Addendum #1 - Issued September 21, 2012

Regarding Bids for **Pre-Engineered Metal Building System (ITB 12-026P)** for Lucas County Engineer Road Maintenance, bid opening scheduled for October 4, 2012.

ADDENDUM NO. 01

**Lucas County Road Maintenance Building
Pre-engineered Metal Building System – Bid Package 12-
026P**

SHEET TITLE
First Floor Plan

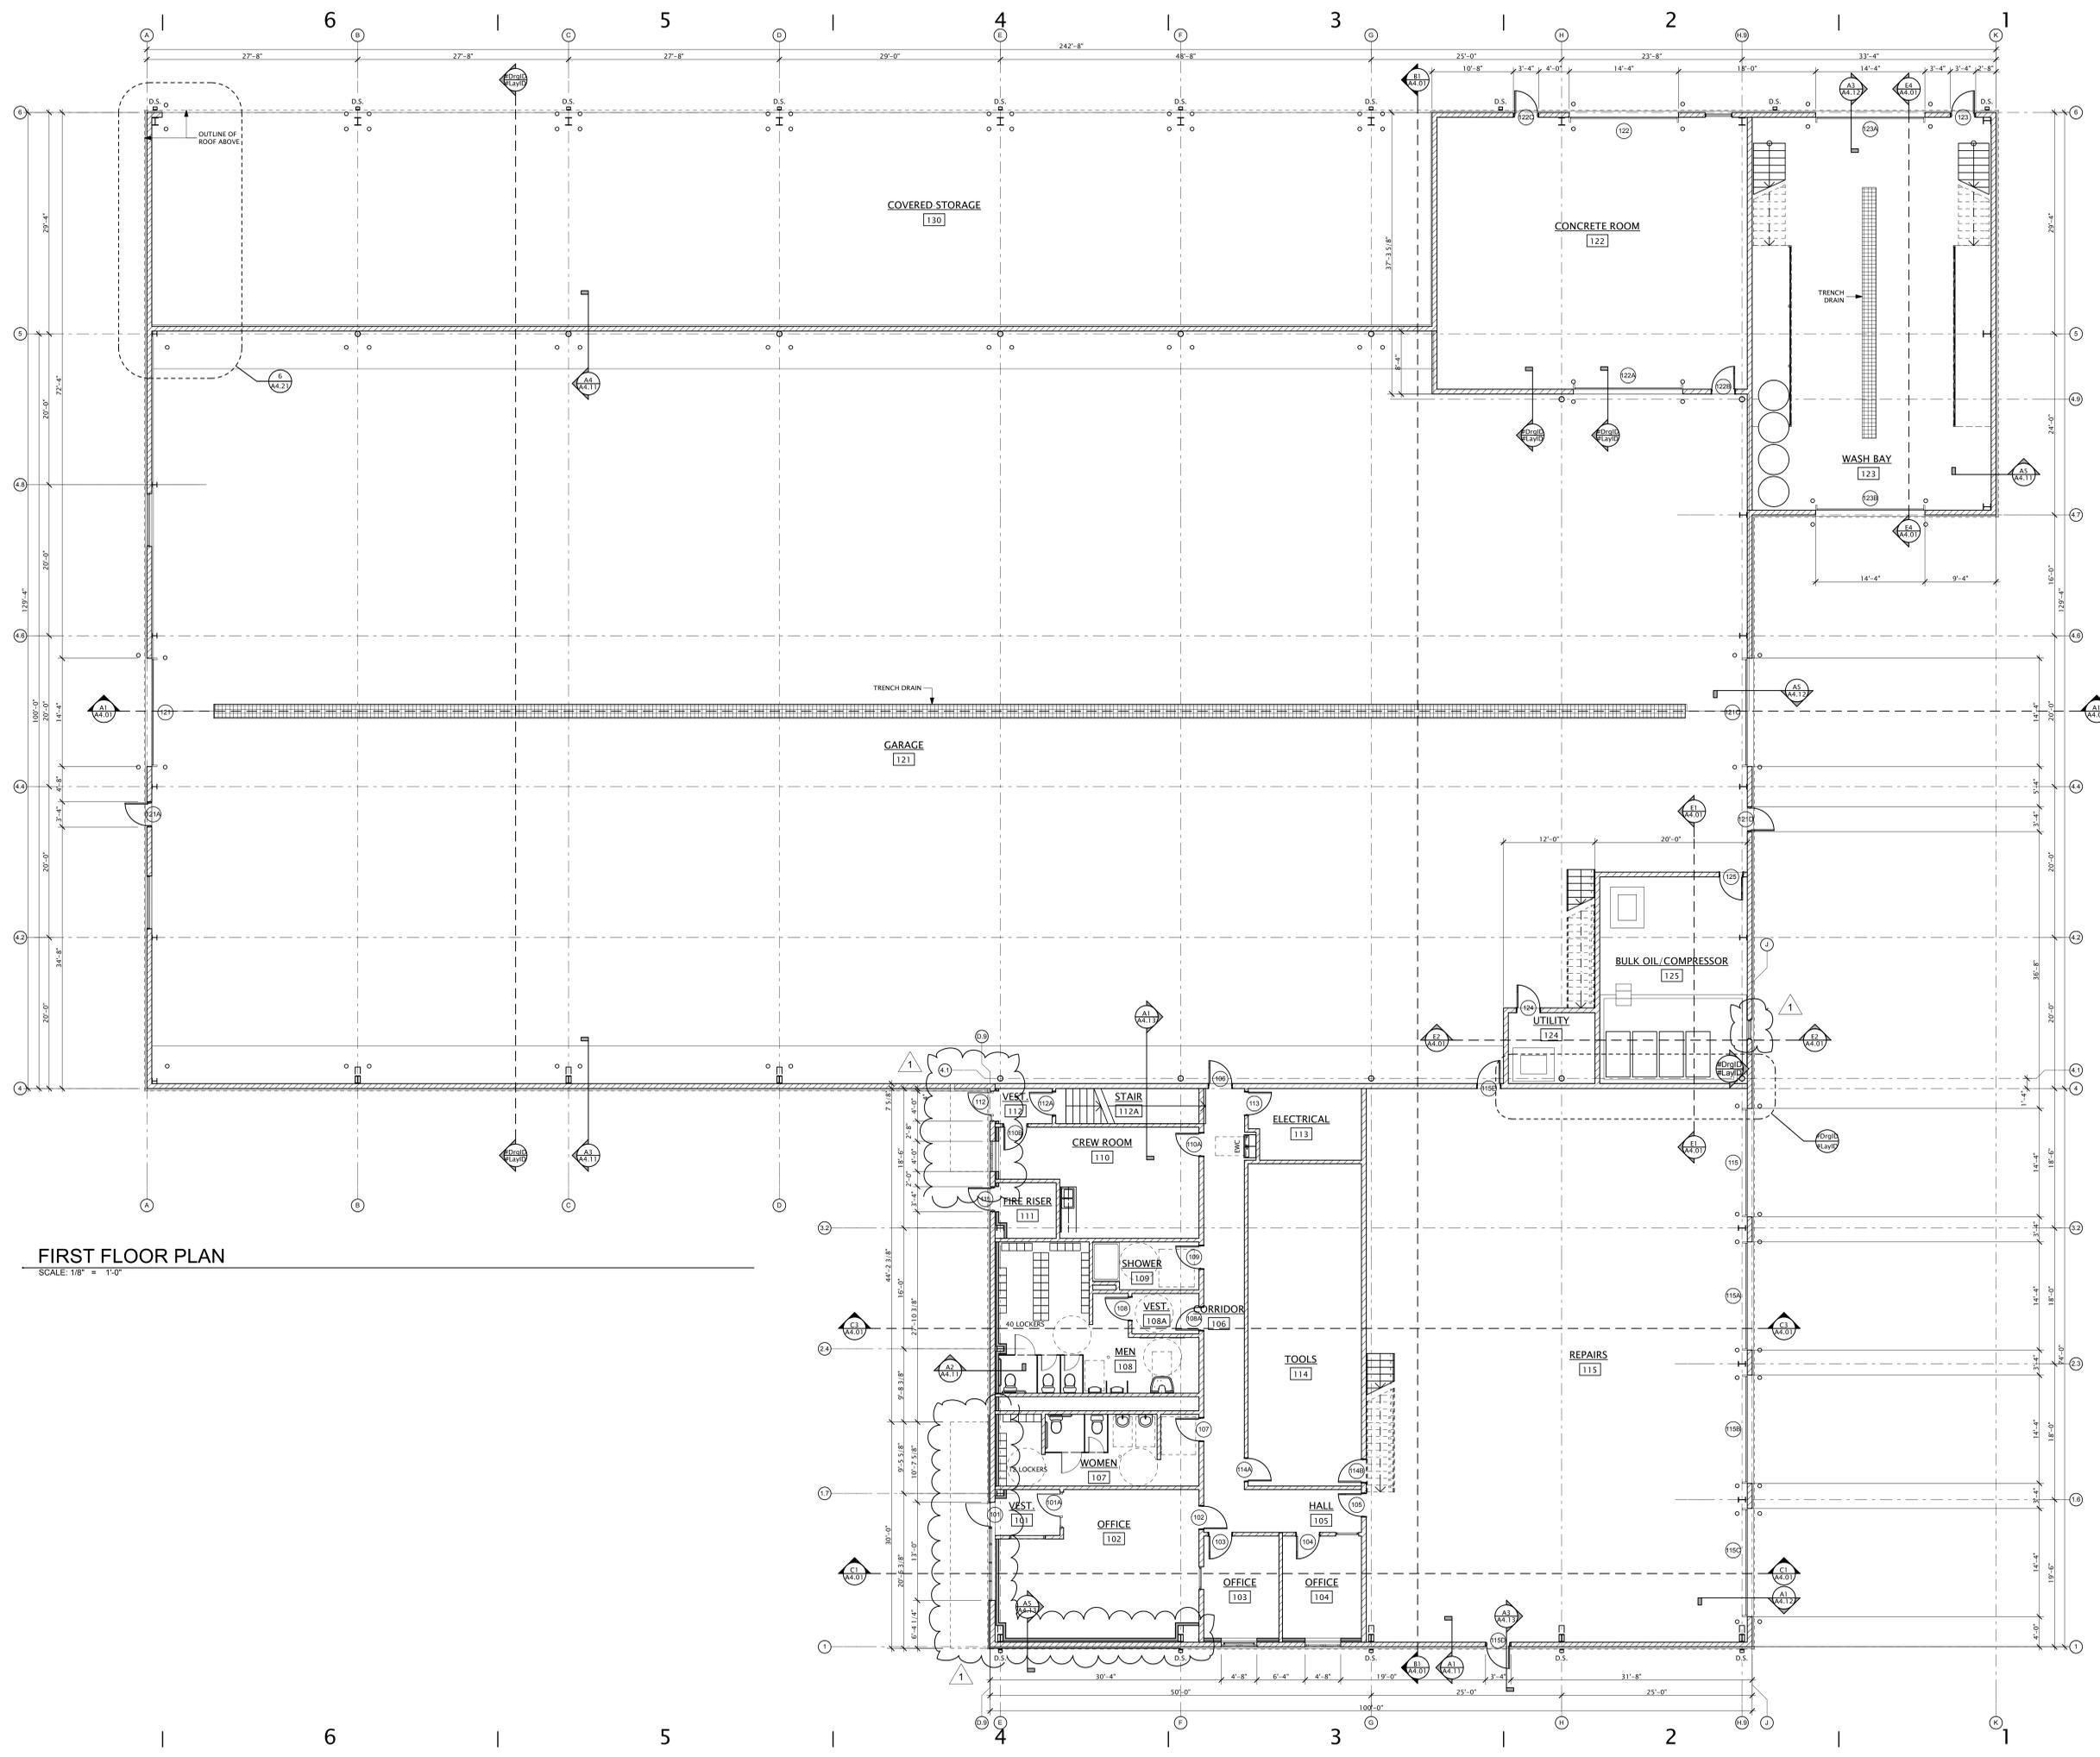
- Item #1 Added storefront entrance and window system along Column Line D.9.
- Item #2 Added entrance canopy construction along Column Line D.9 above doors 101 and 112.
- Item #3 Eliminated two (2) punched window openings and extended metal siding to grade along Column Line 1 between Columns E and G.
- Item #4 Revised louver location along Column Line J between Columns 4.1 and 4.2.

SHEET TITLE
Mezzanine Floor Plan

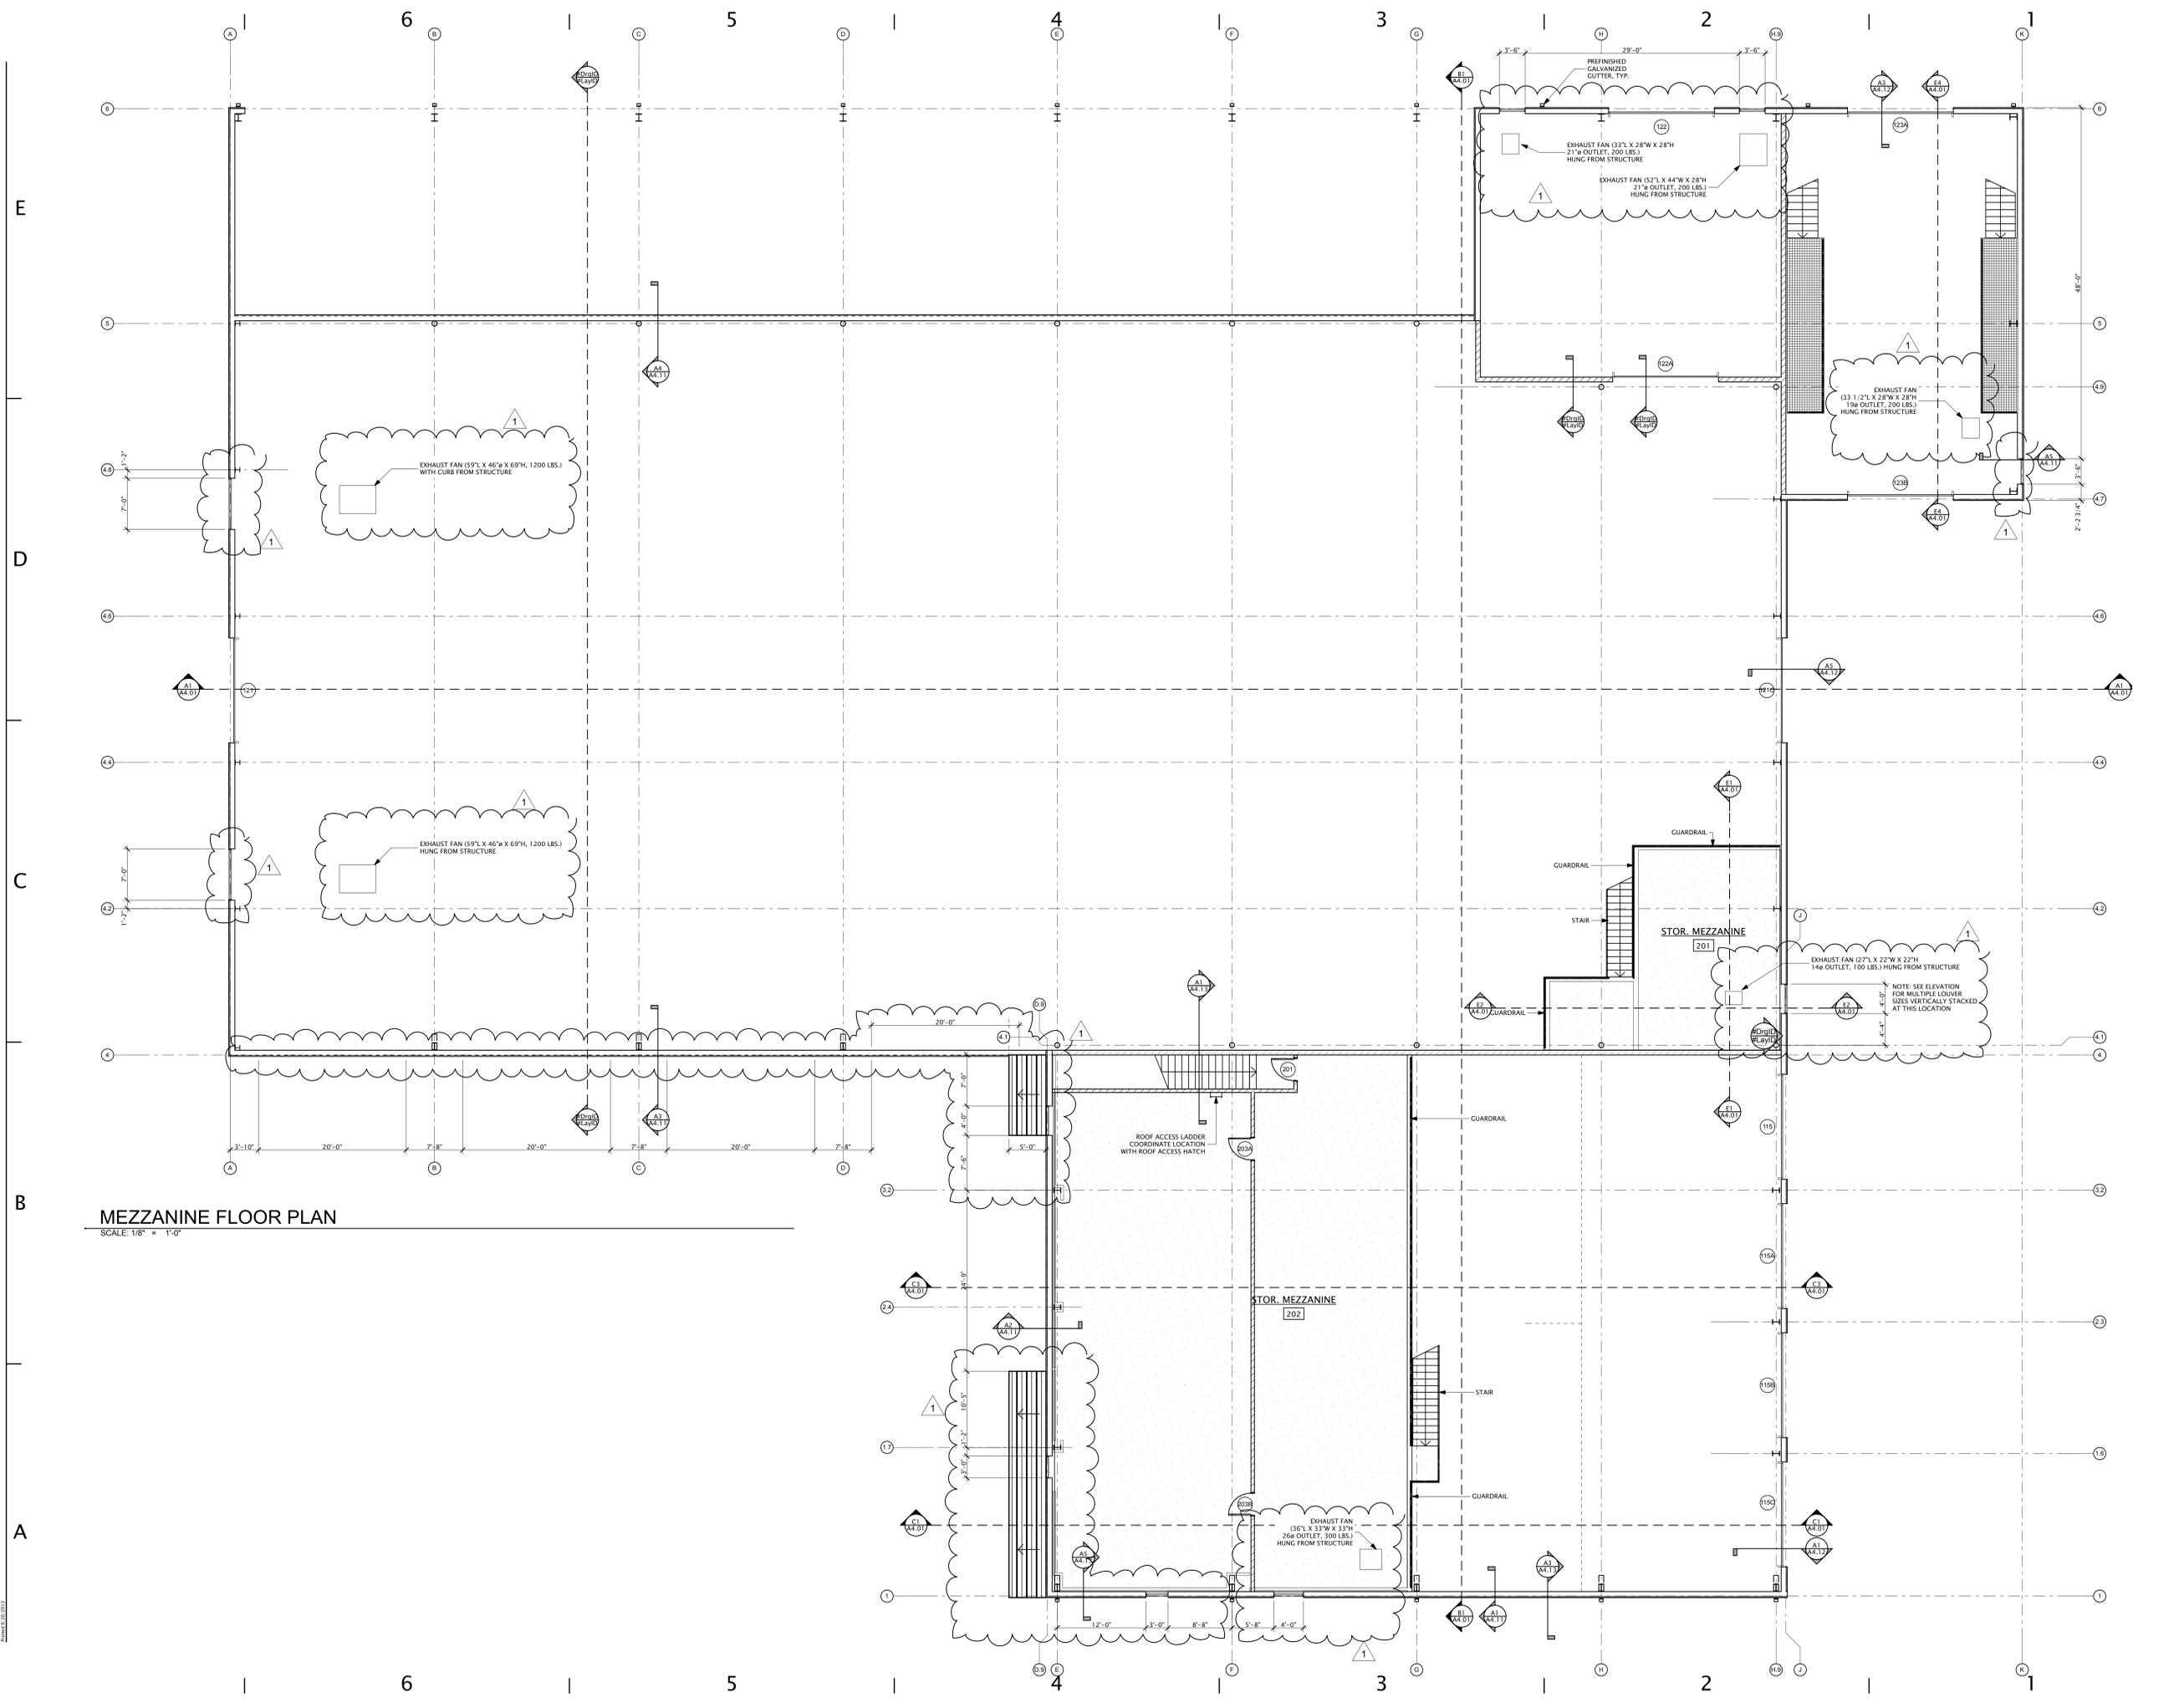
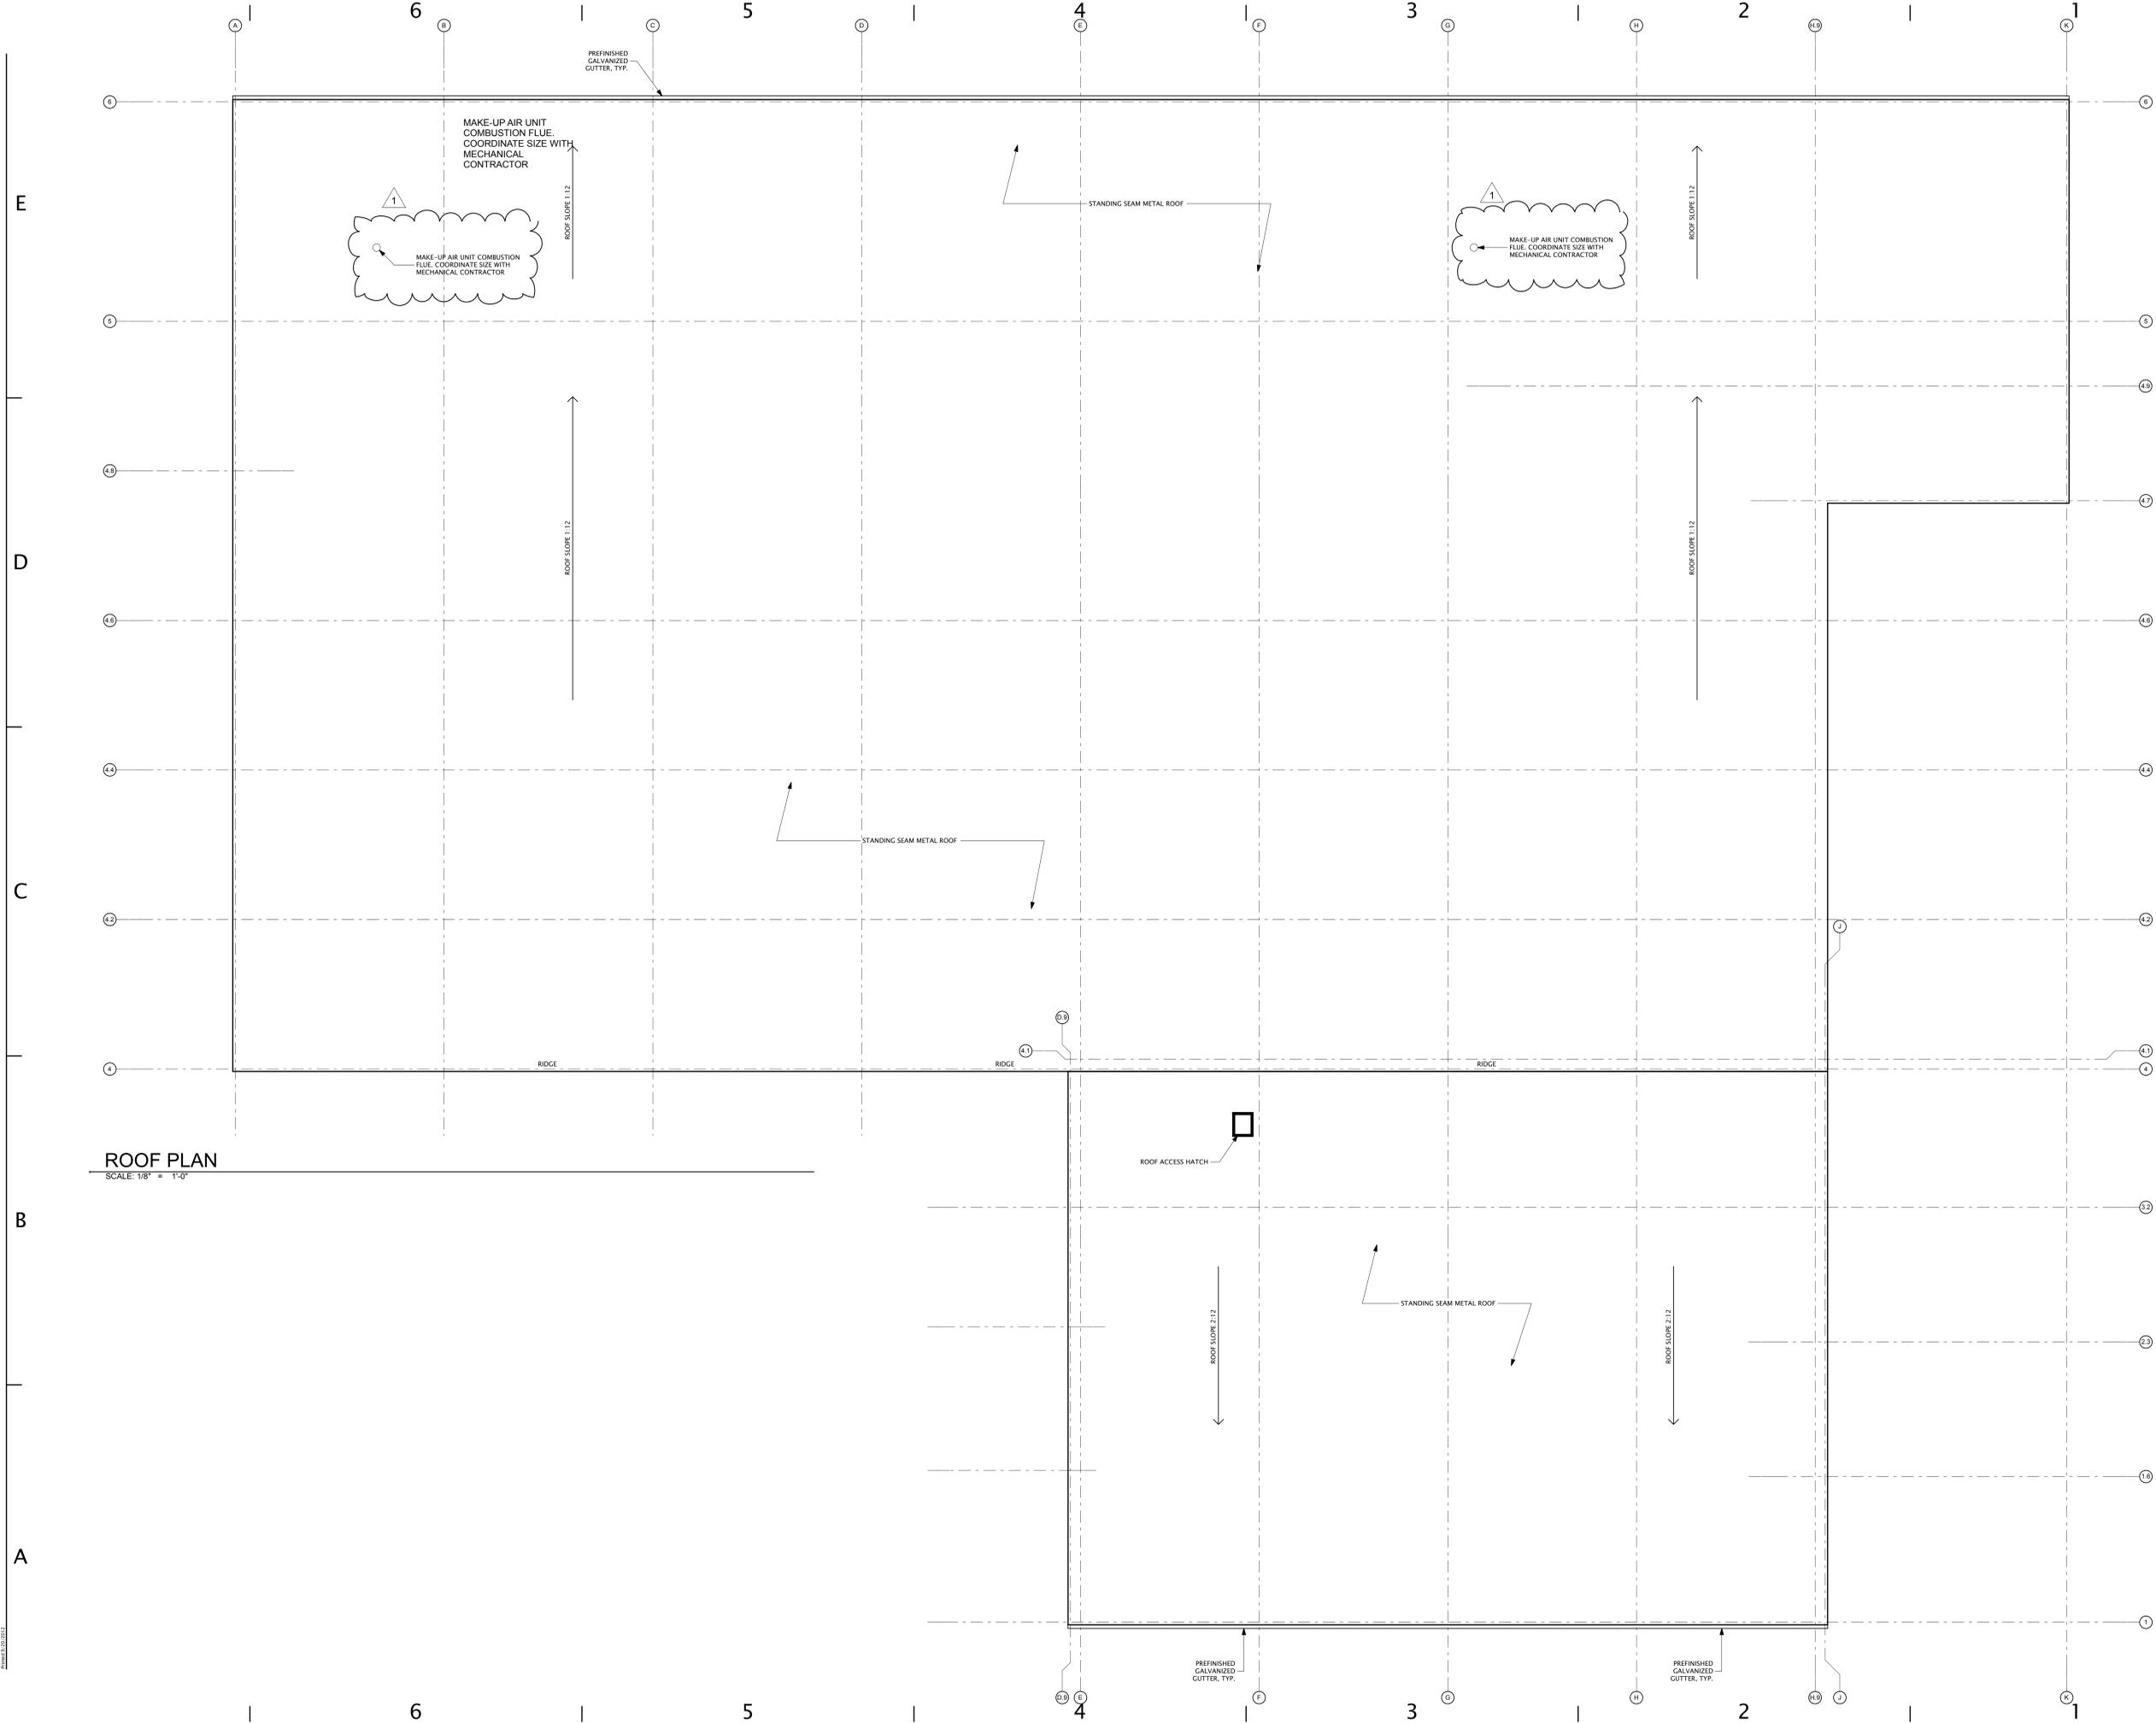
- Item #1 Added louvers to exterior wall along Column Line A.
- Item #2 Added four (4) windows along Column Line 4 between Columns A and D.9.
- Item #3 Added louvers and canopies to exterior wall along Column Line D.9.
- Item #4 Added louvers to exterior wall along Column Line 1.
- Item #5 Added louvers to exterior wall along Column Line J.
- Item #6 Added louvers to exterior wall along Column Line K.
- Item #7 Added louvers to exterior wall along Column Line 6.
- Item #8 Added locations and weights of structure suspended exhaust fan units.
- Item #9 Added locations and weight of structure suspended make-up air unit.
